## **ADDENDUM NO. 1**

**DATE:** January 7, 2021  
**FROM:** City of Grand Junction Purchasing Division  
**TO:** All Offerors  
**RE:** Lorey Drive Improvements Project IFB-4861-21-DH

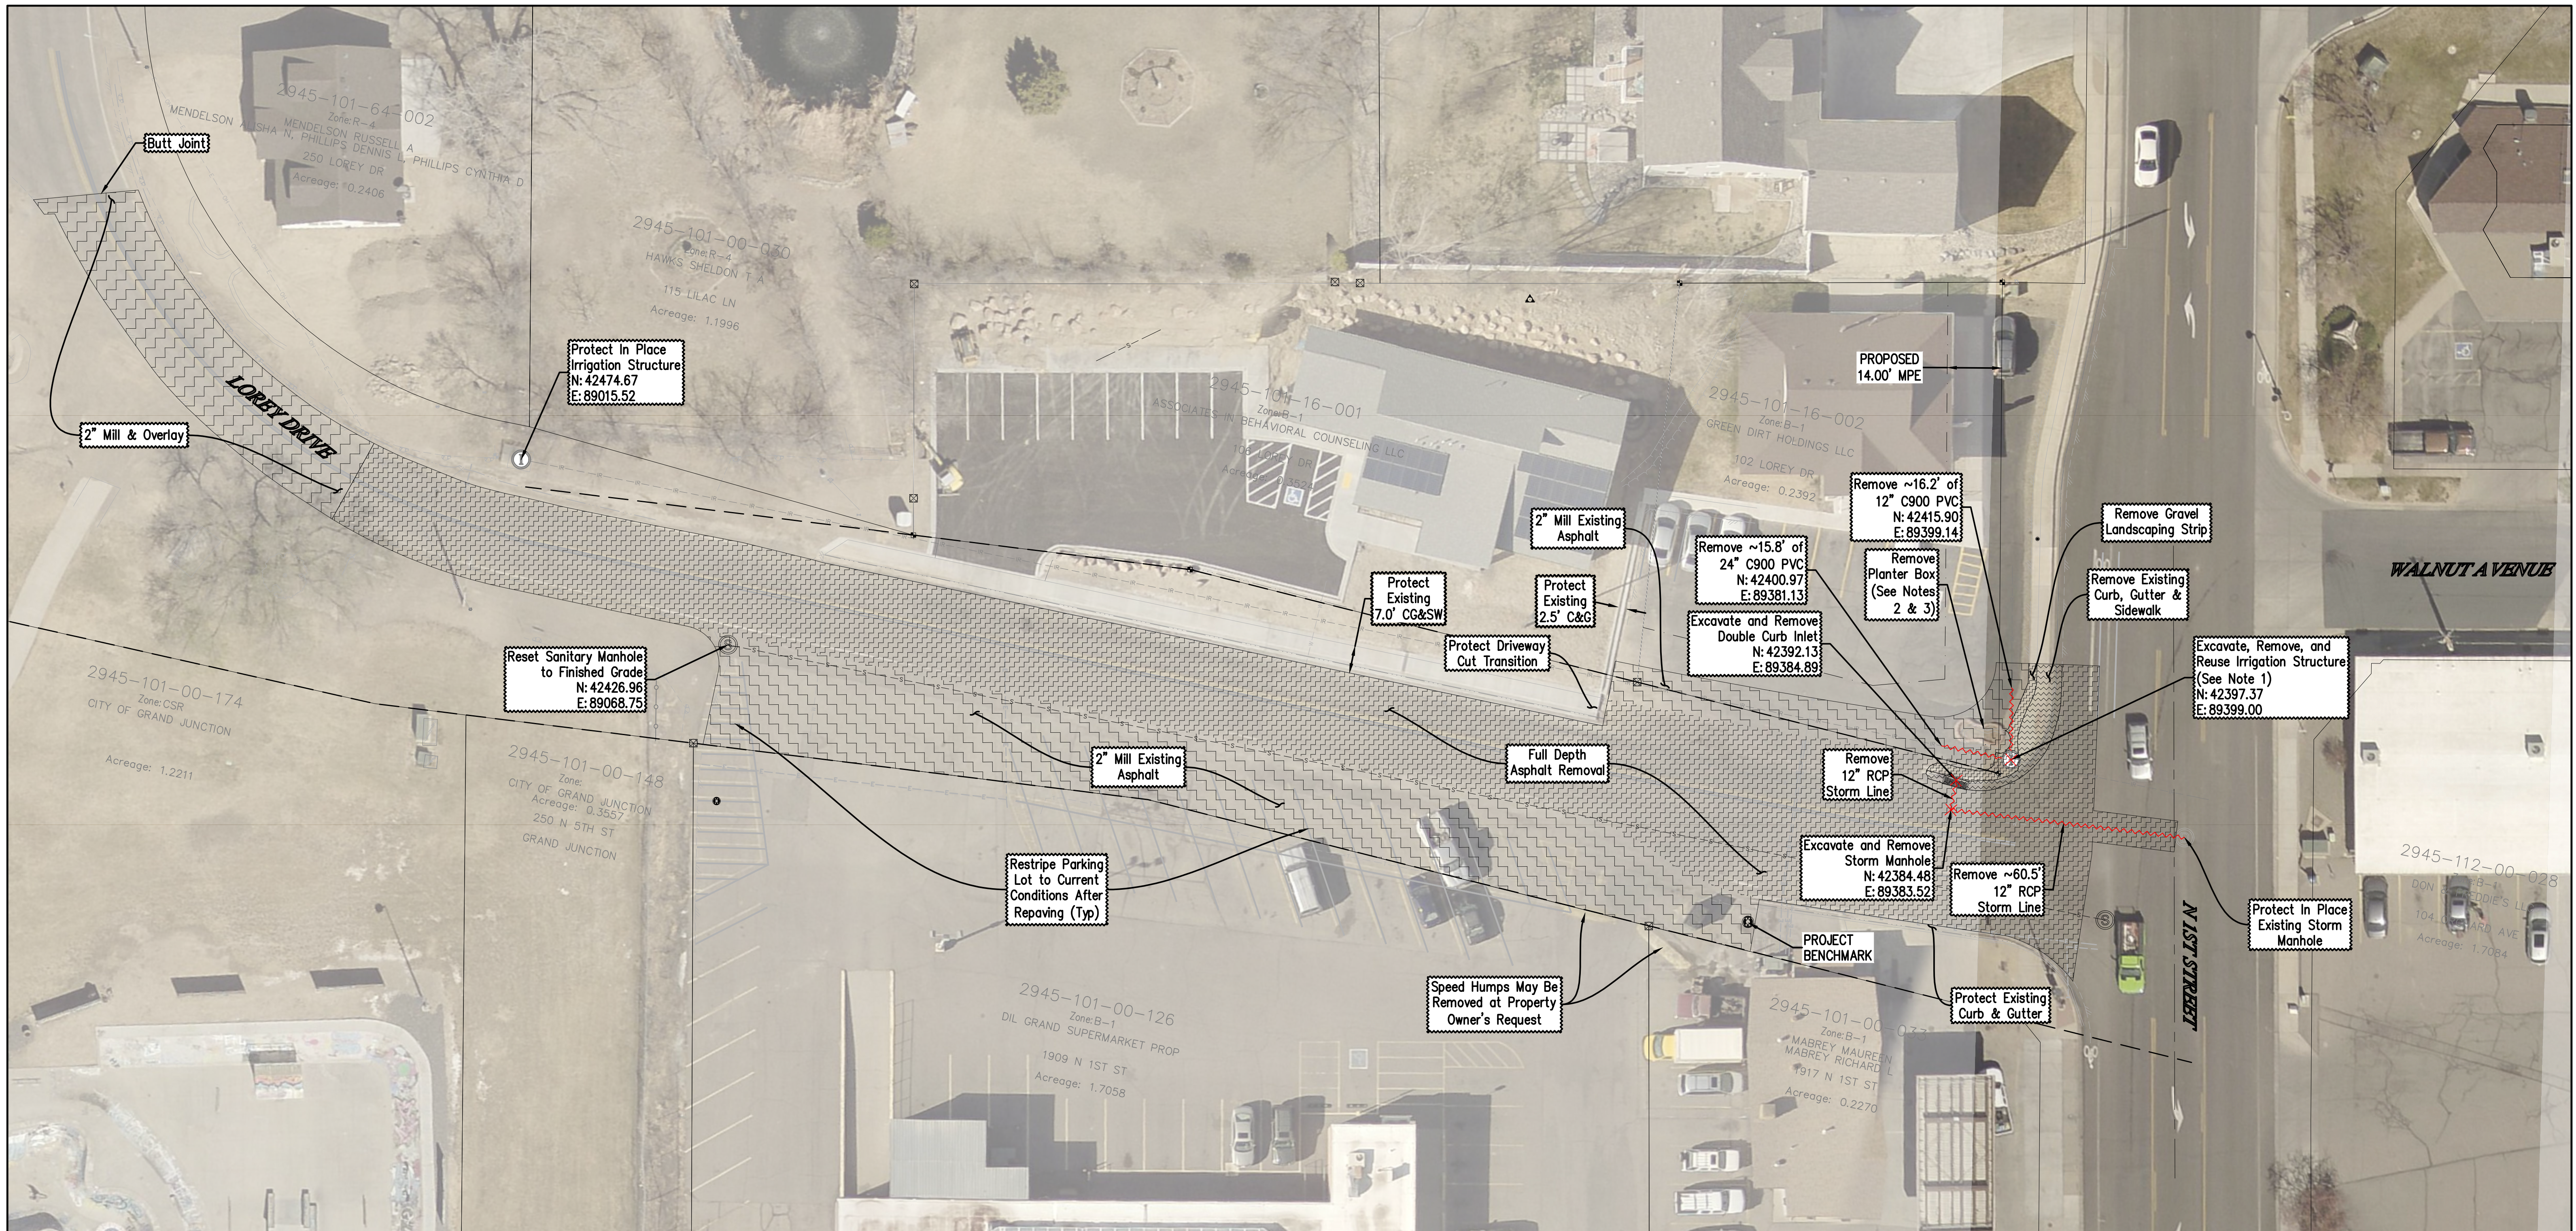
5. Q. There is no pay item or qty for the concrete removal.
  - A. A line item has been added. Please see the revised Bid Schedule.
6. Q. There is no pay item or qty for the 1" mill existing asphalt.

12. Q. The current drawings show 1-inch-thick call outs, but you also mentioned 2 inches. Can you please clarify?

- A. The area called out on the plans as "1" Mill Existing Asphalt" has been revised to a 2" mill. A separate line item for full depth asphalt removal has been added as well. Please see the updated bid schedule.

A. The plans have been revised to show a 2" mill.

<table><tr> <th colspan="3">REVISIONS</th> </tr><tr> <td>3</td> <td>07.Jan.2021</td> <td>Revised Milling Depths</td> </tr></table>
